Maiden Wind Farm  
Benton County, Washington  
Final SEPA Environmental Impact Statement  
and  
Final NEPA Environmental Impact Statement  
Submitted Pursuant to Section 42 USC (Sections 4321 et seq.)  
and WAC 197-11  
by the  
U.S. Department of Energy  
Bonneville Power Administration  
and  
Benton County, Washington

# Maiden Wind Farm Final Environmental Impact Statement Cover Sheet

**Title of Proposed Project:** Maiden Wind Farm

This chapter identifies the specific changes to the text of the Draft EIS. Text changes are organized by the chapters and sections of the Draft EIS. For each change, the location of the change is identified by page and paragraph number of the Draft EIS. Where text has been modified, deleted text is indicated in “~~striketrough~~” format and new text is underlined.

**Figure 3.2-1  
 Land Use, Ownership,  
 and County Designations  
 Maiden Wind Farm EIS**

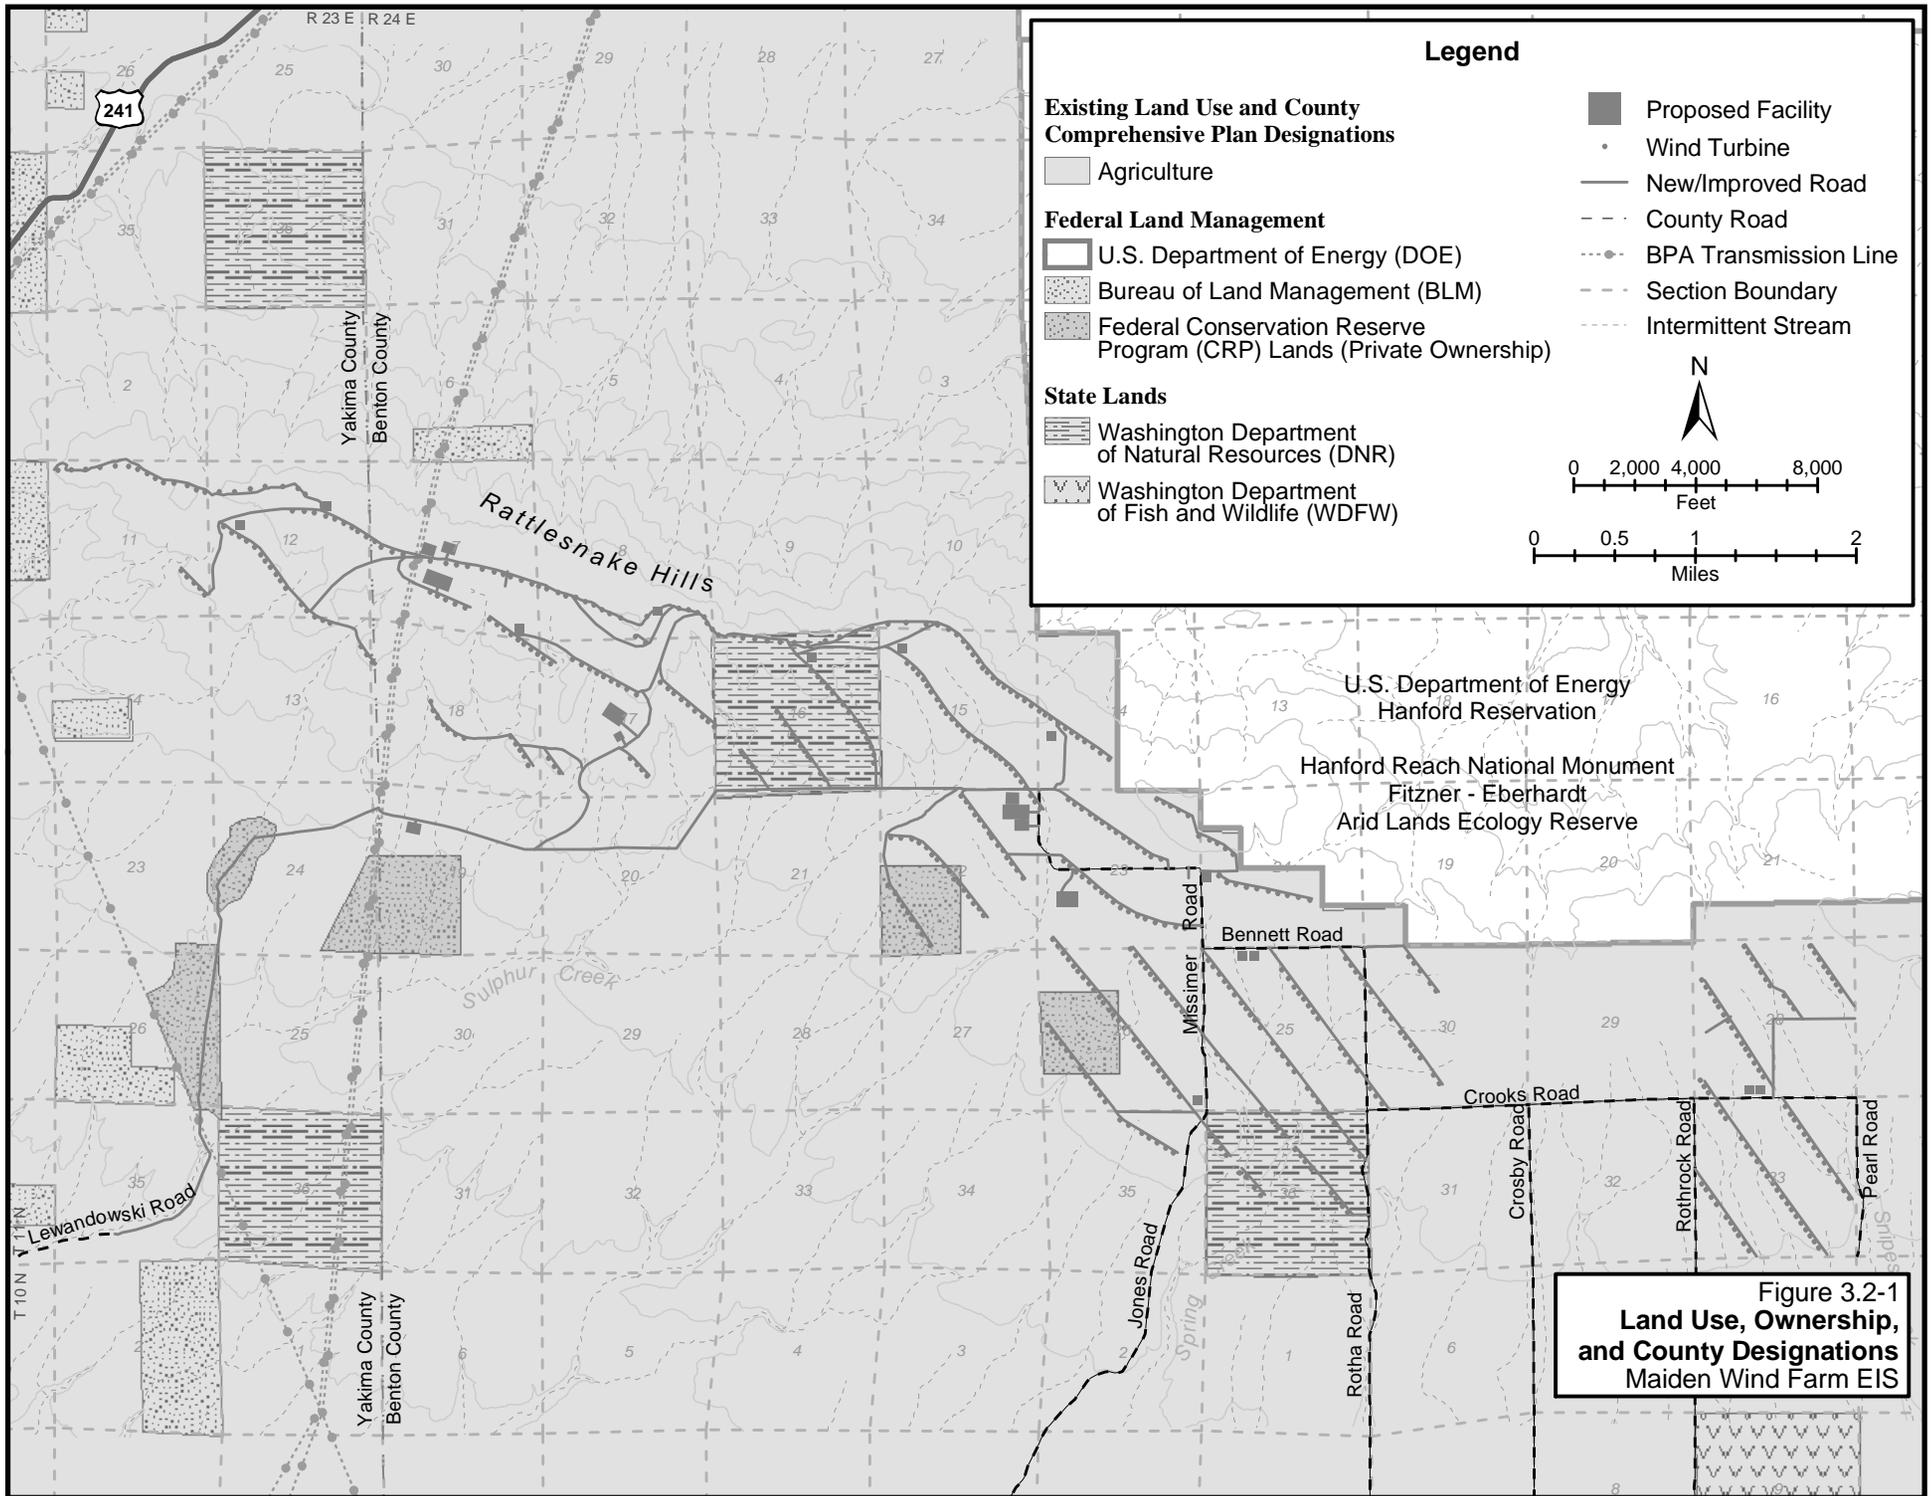
Page 3-4, Figure 3.2-1 is replaced with the figure following this page:

**Comment 30:** *Land Use and Recreation: The DEIS lacks any reference to the WDFW Wildlife Area within the study area. The Wildlife area is more than three sections of public land (Sections 9, 14, 15, and 22, Range 25 East, Township 10 North) only one mile south of Section 33 between Rothrock Road and Pearl Road. Public uses include but are not limited to, hunting, photography, horseback riding, hiking, and wildlife viewing. Additionally, the Department of Natural Resource (DNR) sections within the study area are open to the same uses as the Wildlife areas. Regardless of agricultural leases, as long as there is public access to DNR sections, public recreation is allowed. The DEIS doesn't recognize or evaluate any of these public access issues. There should be a full impact analysis for these public lands.*

**Response:** EIS Section 3.2 has been corrected to reflect the existence of the WDFW Wildlife Area noted in the comment and to provide a discussion of potential impacts. The proposed project is not expected to have any direct environmental impact or affect public access to the referenced WDFW Wildlife Area because of the distance of this wildlife area from the project area. No public access constraints for the WDFW lands would be imposed under the proposed project that would differ from the current situation. There is no public access to DNR's section 16 T11N, R24E, except by landowner permission, because it is surrounded by private land. Access to DNR section 36 T11N, R24E, would likely be restricted for safety reasons if turbines were to be located there, pursuant to agreements between DNR and Washington Winds.

Figure 3.9-1  
 Roadway Network and  
 Average Daily Traffic  
 Maiden Wind Farm EIS

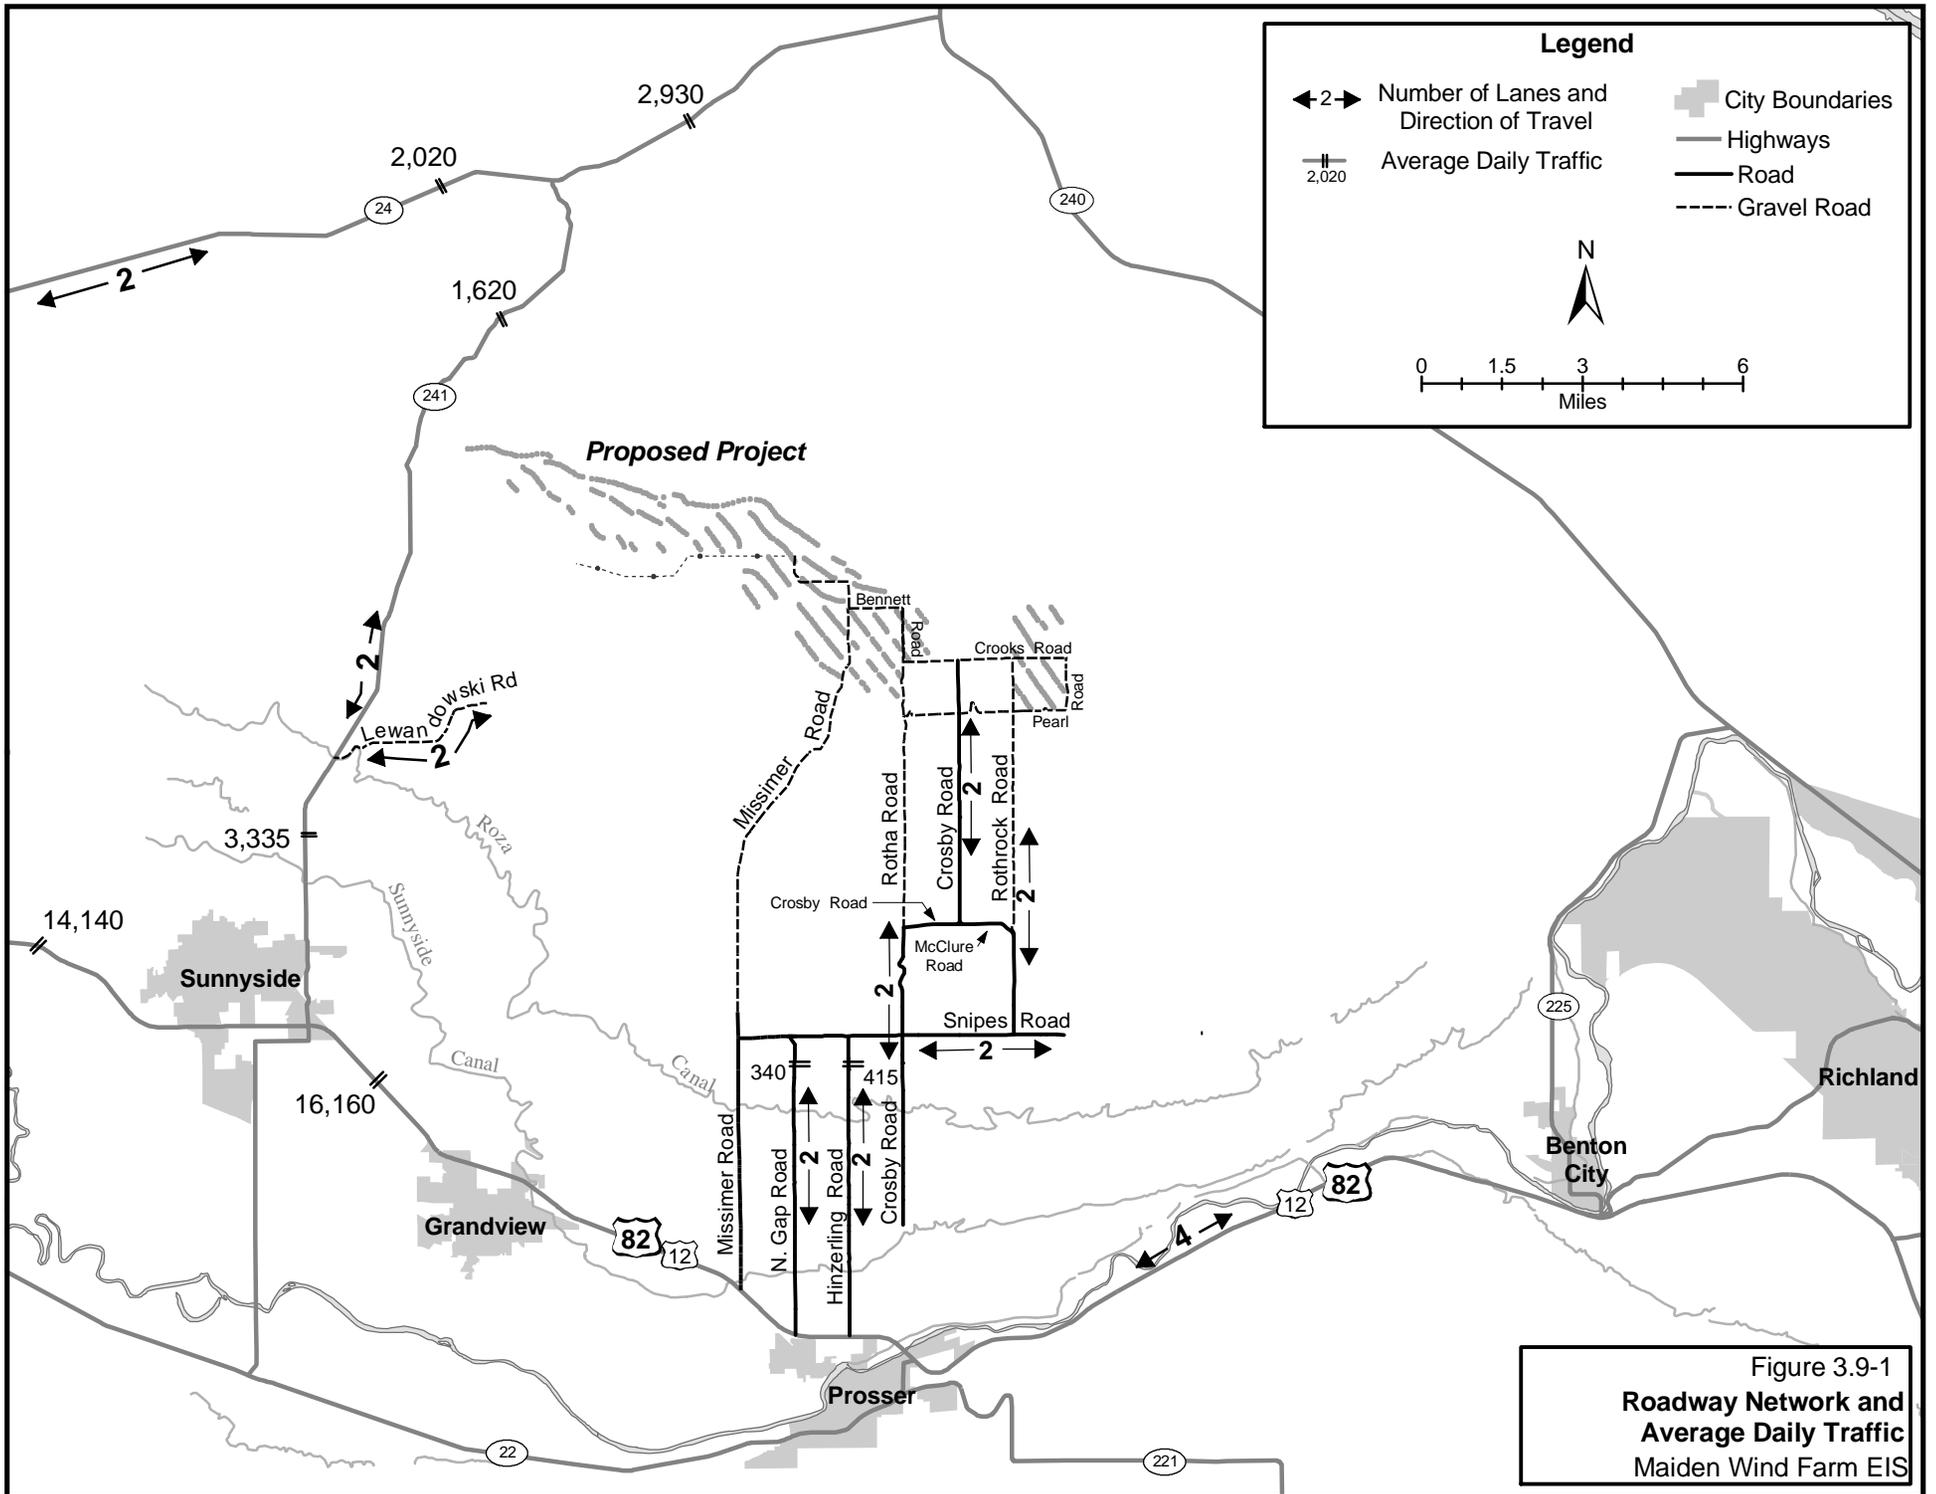
Page 3-102, Figure 3.9-1 is replaced with the figure following this page.

**Response:** Thank you for the information. EIS Figure 3.9-1 has been corrected to show Lewandowski Road as a gravel road.
